# 802.3aj™

IEEE Standard for Information technology—
Telecommunications and information exchange between systems—
Local and metropolitan area networks—
Specific requirements

**Amendment: Maintenance 7**

IEEE Std 802.3aj-2003, Maintenance 7 is an amendment to IEEE Std 802.3. It includes corrections and clarifications to both IEEE Std 802.3-2002 and IEEE Std 802.3ae. In a few cases text published in IEEE Std 802.3-2002 is modified by IEEE Std 802.3ae-2002 and is subsequently modified by IEEE Std 802.3aj-2003. IEEE Std 802.3aj-2003 does not include any modifications to the text of IEEE Std 802.3af-2003.

Figure 13–1 — Example of maximum transmission path with five repeater sets enabled by Model 2 Transmission System validation

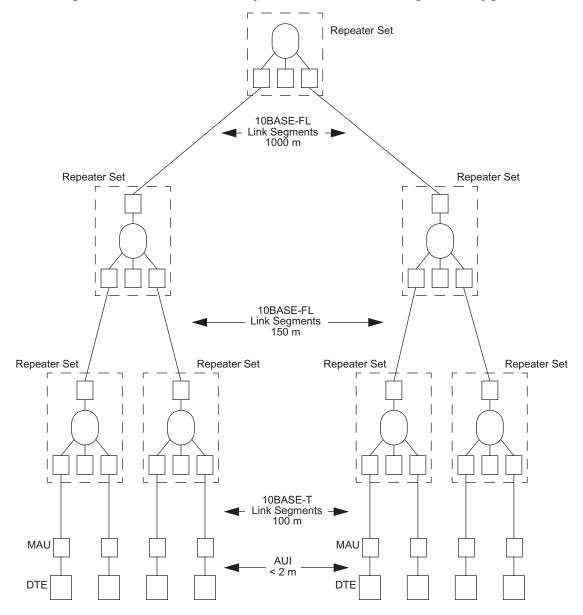
Insert new Figure 13-1 into subclause 13.1 as follows. Renumber all existing Clause 13 figures.

Figure 36-7b-PCS receive state diagram, part b

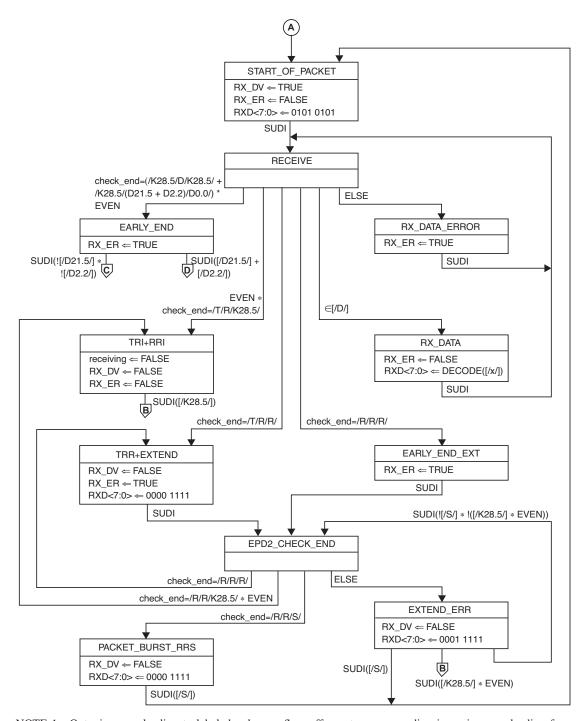
Change notes of Figure 36-7b as follows:

NOTE\_1—Outgoing arcs leading to labeled polygons flow offpage to corresponding incoming arcs leading from labeled circles on Figure 36–7a, and vice versa.

Figure 43-3 - Frame Collector state diagram

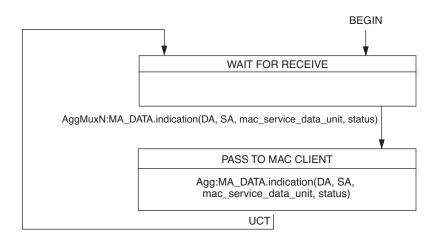
# Replace Figure 43–3 with the following:

Figure 43-4 - Frame Distributor state diagram

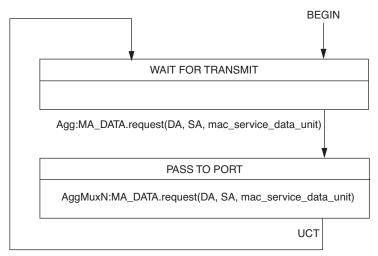
#### Replace Figure 43–4 with the following:

Figure 43-5 - Aggregator Parser state diagram

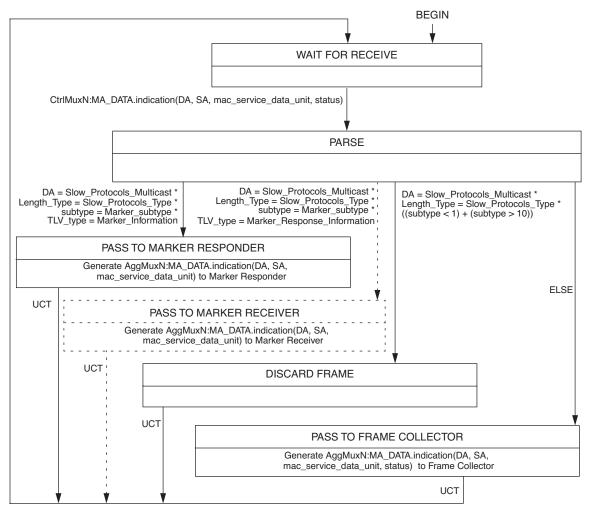
#### Replace Figure 43–5 with the following:

Figure 43-6-Control Parser state diagram

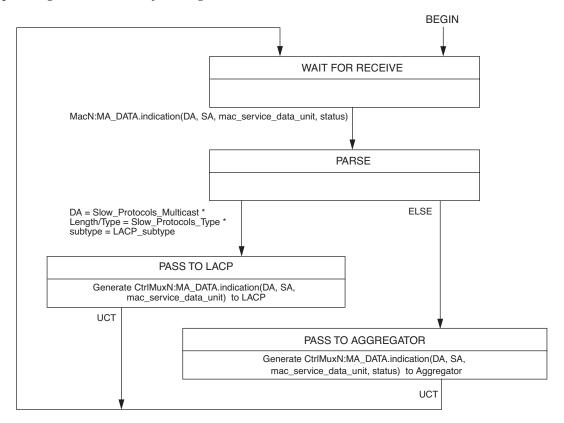
# Replace Figure 43–6 with the following:

Figure 31B-2-PAUSE Operation Receive state diagram

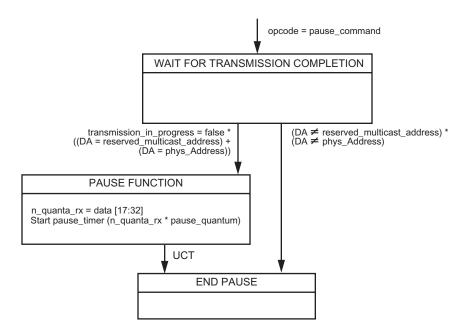
#### Replace Figure 31B-2 with the following:
